Subject: CERTIFICATE OF COMPLIANCE NO. 9292 FOR THE MODEL NO. PATRIOT PACKAGE: Follow-up Information Requested during Conference Call Held June 2, 2005 - DOCKET No. 71-9292; TAC No. L23770

Enclosure 1: Response to Follow-up Questions

Application for Certificate of Compliance for the Patriot BWR Fuel Shipping Package

Figure 1 USLs for 49 LWR-type fuel critical experiments, k_{eff} vs AEF (0.0 – 0.5 eV)

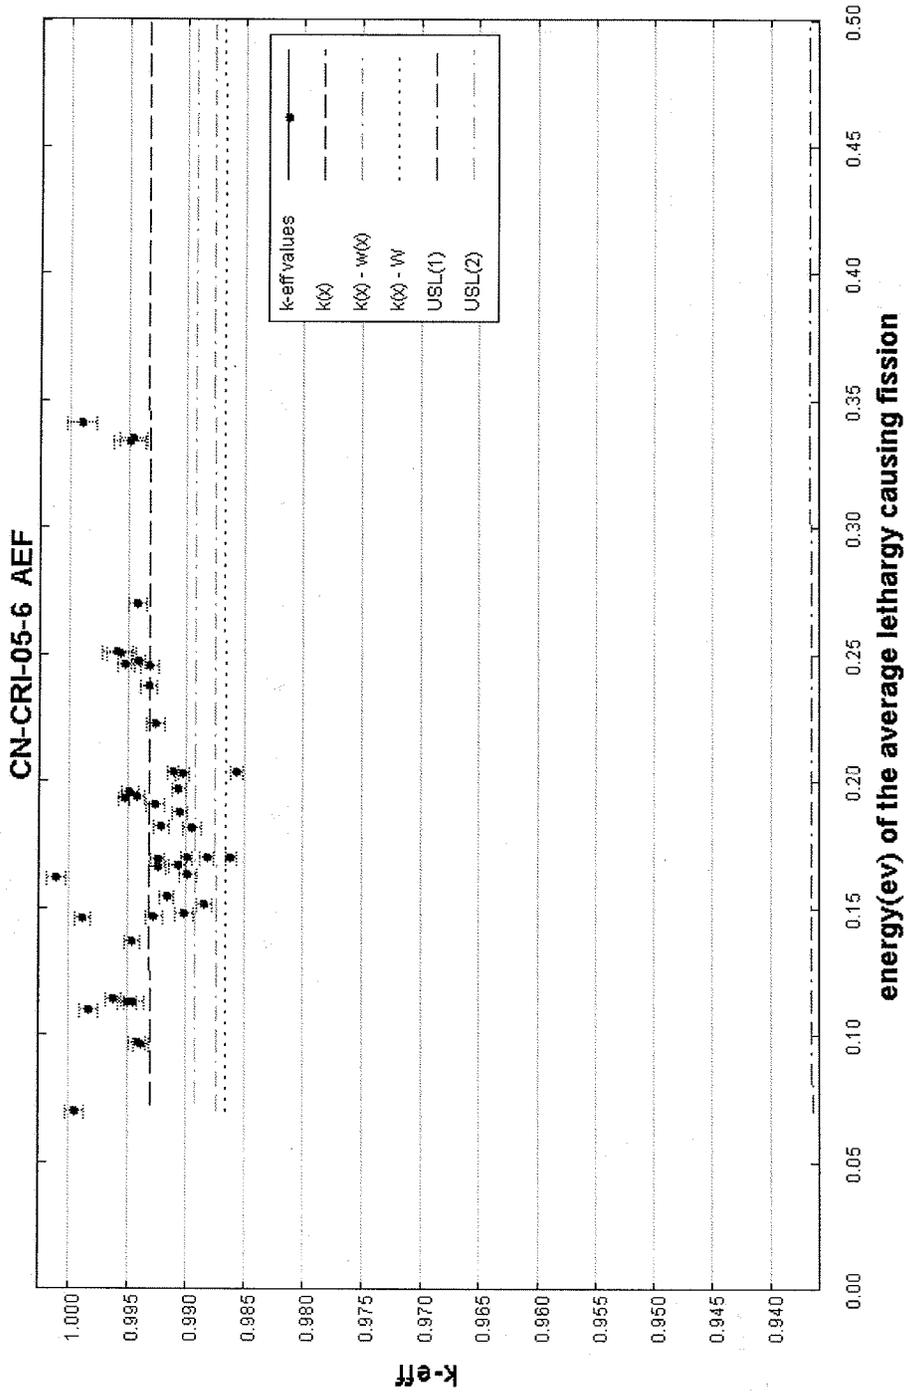
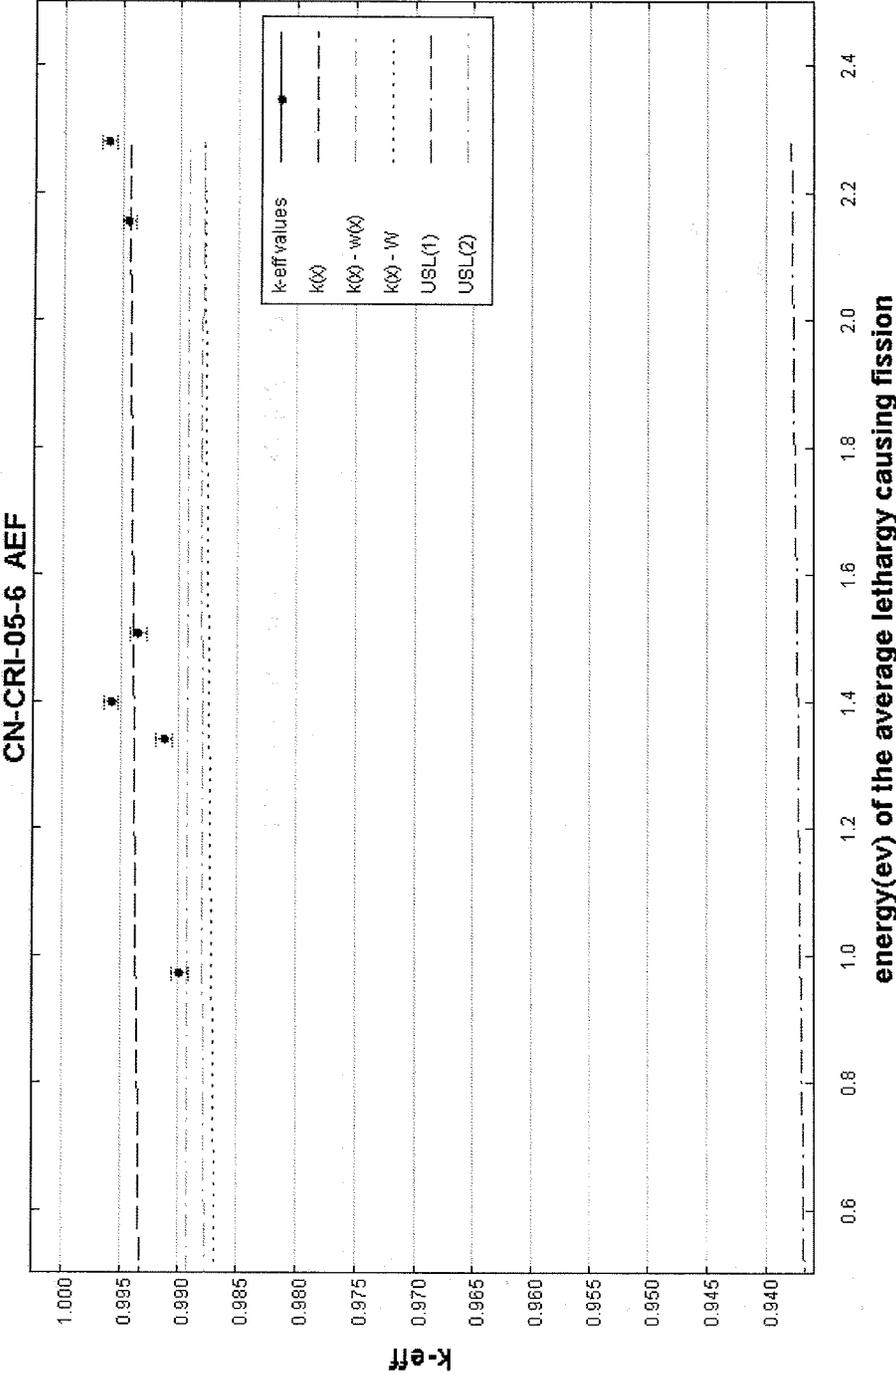
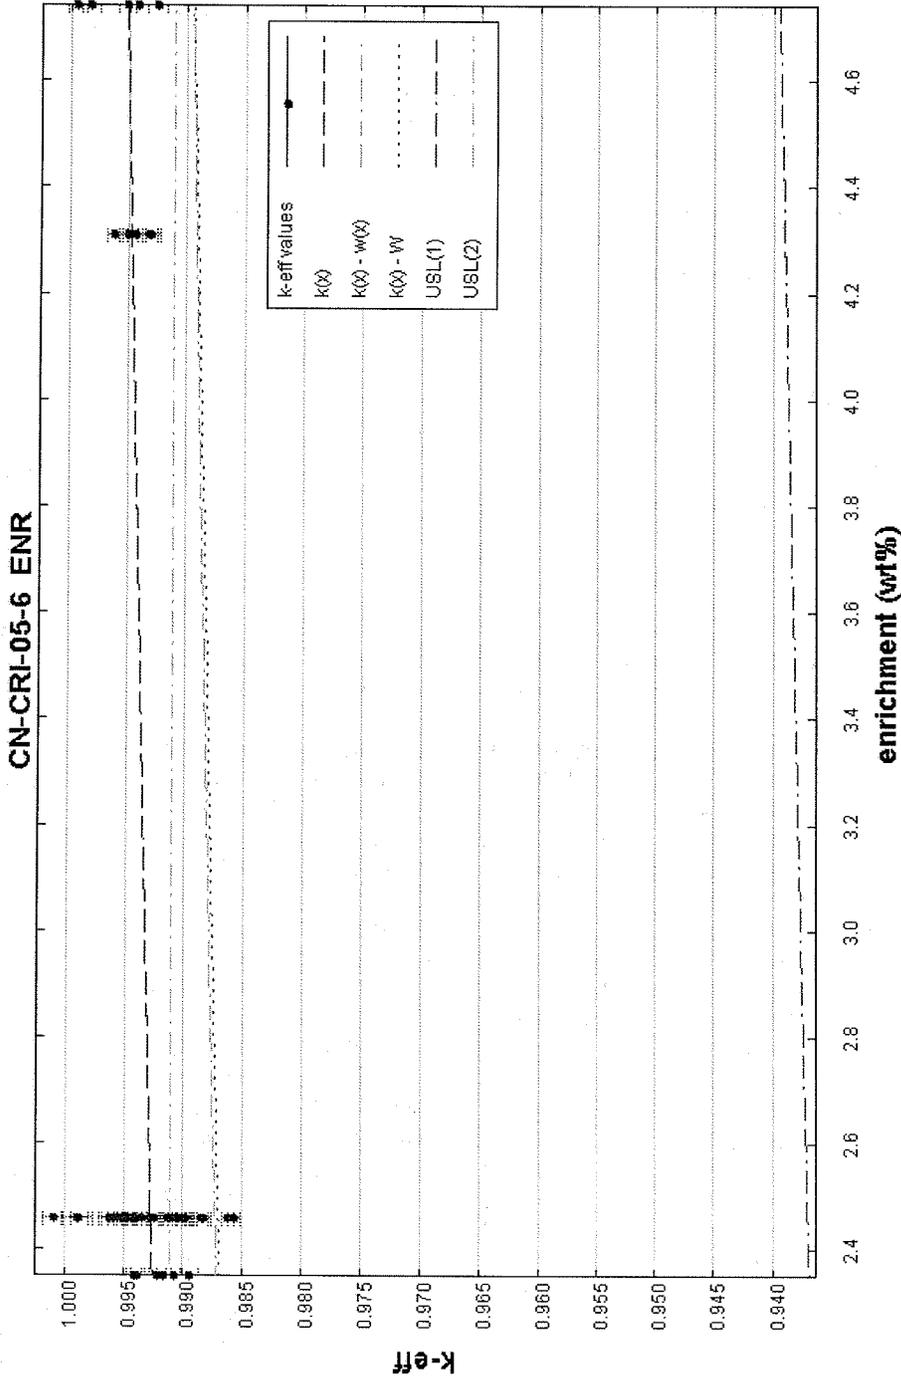
On page 6 of 13 in our RAI response (NMS-NRC-05-005) Westinghouse states,

“The energy (ev) of the average lethargy causing fission for the PATRIOT package that results in a maximum keff over the range of interspersed moderation densities and moderator configurations is approximately 0.6 ev. Only six of the critical benchmark critical experiments have EALF that is greater than 0.5 ev, but the *results show no significant trend in bias vs. energy. The largest bias results from a the correlation to the enrichment parameter*, and results in an upper safety limit of 0.9343 including a 0.05 arbitrary margin to ensure subcriticality.”

Provide trend data to substantiate these statements.

The USLSTATS output for AEF and ENR are provided to address the items above. Further, the data are graphed as follows:

- USLs for 49 LWR-type fuel critical experiments, k_{eff} vs AEF (0.0 – 0.5 eV),
- USLs for 49 LWR-type fuel critical experiments, k_{eff} vs AEF (0.5 - 2.5 ev), and
- USLs for 49 LWR-type fuel critical experiments, k_{eff} vs enrichment

Figure 6A-4 Typical 10x10 Assembly Design

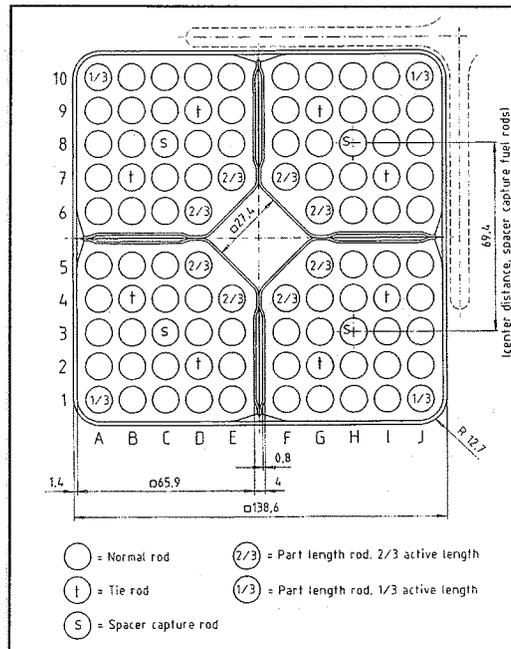
Please provide the wording to be included in the Certificate of Compliance that describes the contents. Specifically, information on the location of Gd₂O₃ rods and partial length rods must be included, as well as the minimum gadolinia loading.

Below please find the current CoC wording and the proposed new wording. Rather than refer to any sketch or paragraph in the SAR, it was decided to provide a verbal description of the three loading sets, exactly as was done for the original contents. Note also that while checking the wording of Section 6A, another typographical error was discovered on page 6A-6. Paragraph (b) of Section 6A.2.1.3 should read "24 per mini-bundle" and not "23 per mini-bundle." This is corrected in Revision 2.

(2) *Description of Assembly Type #2*

Each assembly is made up of 96 fuel rods having a maximum active fuel length of 150 inches. Each assembly contains four-1/3 length rods and eight-2/3 length rods. The 1/3 length rods are located on the outside corners of the assembly. The eight-2/3 length rods, two per sub-assembly, are located on the geometric diagonal toward the center of the assembly. The fuel pellet diameter is 0.848 nominal, encapsulated in 0.061 cm nominal zirconium alloy cladding. There is a 0.0075 cm gap between the pellets and the cladding. The maximum U-235 enrichment of any fuel rod is 5.0 weight percent. Each assembly contains water holes in the four center rod positions of the assembly. Three different fuel package loadings have the following specifications:

- (i) *Maximum U-235 enrichment of any rod is 5.0 weight percent; There shall be 84 rods, 21 per mini-bundle; There shall be a minimum of eight Gd₂O₃-UO₂ rods per assembly, each having a Gadolinia content of at least 4.0 wt%. These eight Gd₂O₃-UO₂ rods shall be placed two to a mini-bundle, arrayed symmetrically about the assembly. They shall not be placed on the periphery or the outer corner; There shall be 12 water holes, three in each mini-bundle. One water hole shall be on the outside corner and the other two shall be on the geometric diagonal towards center of the assembly. Other fuel rods containing gadolinia may be present.*

- (ii) *Maximum U-235 enrichment of any rod is 5.0 weight percent; There shall be 92 rods, 23 per mini-bundle; There shall be a minimum of ten Gd₂O₃-UO₂ rods per assembly, each having a Gadolinia content of at least 4.0 wt%. These ten Gd₂O₃-UO₂ rods shall be arrayed symmetrically about the assembly and along a major diagonal. They shall not be placed on the periphery or the outer corner; There shall be four water holes, one in each mini-bundle, on the outside corner. Other fuel rods containing gadolinia may be present.*

- (iii) *Maximum U-235 enrichment of any rod is 5.0 weight percent; There shall be 96 rods, 24 per mini-bundle; There shall be a minimum of twelve Gd₂O₃-UO₂ rods*

per assembly, each having a Gadolinia content of at least 4.0 wt%. These twelve Gd₂O₃-UO₂ rods shall be arrayed symmetrically about the assembly and along a major diagonal. They shall not be placed on the periphery or the outer corner. Other fuel rods containing gadolinia may be present.
